TENNESSEE VALLEY AUTHORITY

In the Matter of  
Tennessee Valley Authority

) Docket No. 070-1622

This is in response to your December 8, 1982 letter to me concerning additional questions to SNM-1476 amendment application, Control No. 21345. Enclosed is our response to each question.

FIG. 1 - NEGATIVE PRESSURE

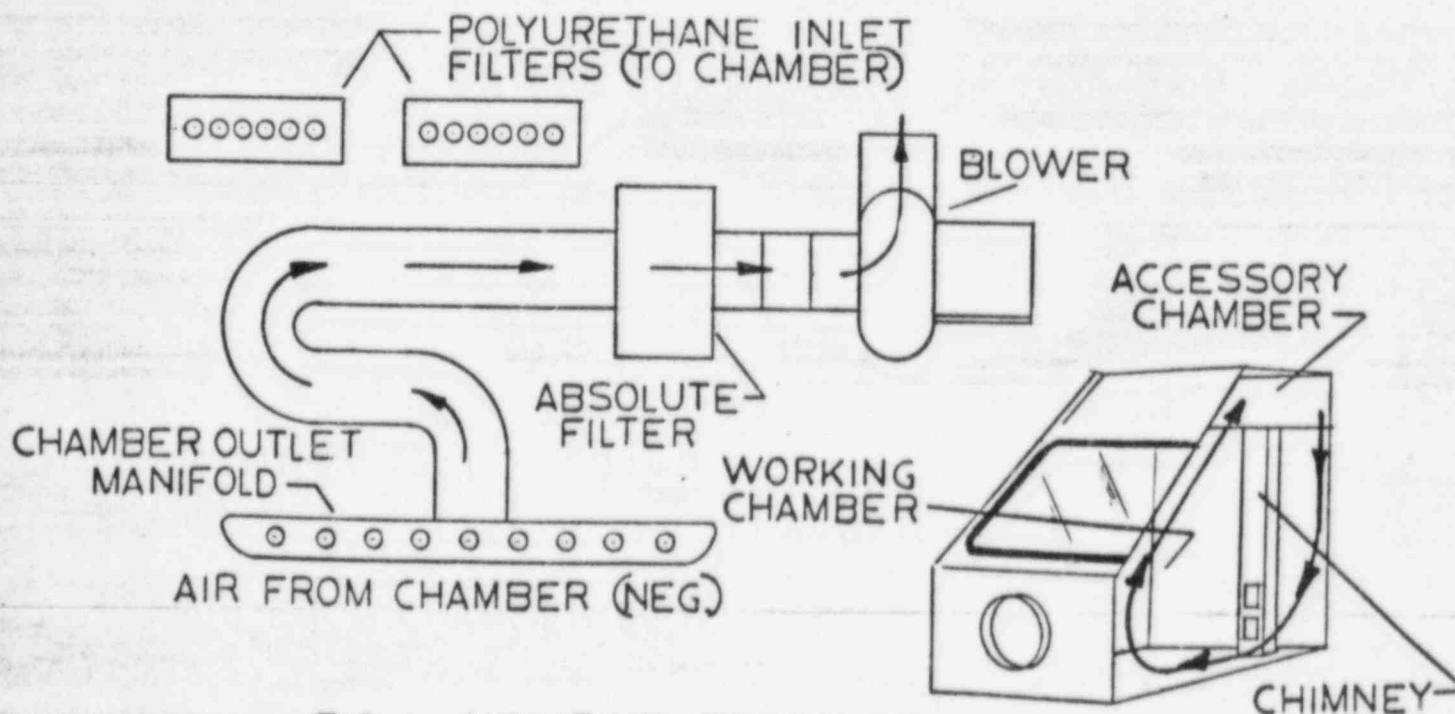
Identify the manufacturer and model number, if any, of the glove box used with your radioactive material program and provide technical specifications for this device. A picture of the glove box would be helpful. Also, provide a diagram of the ventilation system associated with the glove box and describe the individual operations performed in the glove box under both open and closed process conditions. Also, describe the airborne contamination created by such operations and identify the filtration system used to collect particle effluents, if any.

The glove box is manufactured by Labconco Corporation, Model 50000. It is essentially as shown in the attachments except that it does not have a transfer chamber in the door. Airflow through the glove box is as shown in the sketch and then exhausts outside the building through a wall that is immediately behind the glove box.

The boxes are normally assembled for the mode of operation. The room air passes through the polyurethane air inlet filter located on the back stack of the glove box. The even flow of air comes out of the holes in the top back and proceeds through to the manifold on the top front of the box. The air then passes through one "absolute" filter in the standard Bacteriological glove box, or two absolute filters in the standard Radioisotope glove box, into the blower intake where it is exhausted either into the room or away through a 2" diameter flexible hose. Additional filters may be coupled to the exhaust. All tubing is 2" internal diameter and all connectors are 2" external diameter, thus making many "set-up" variations possible.
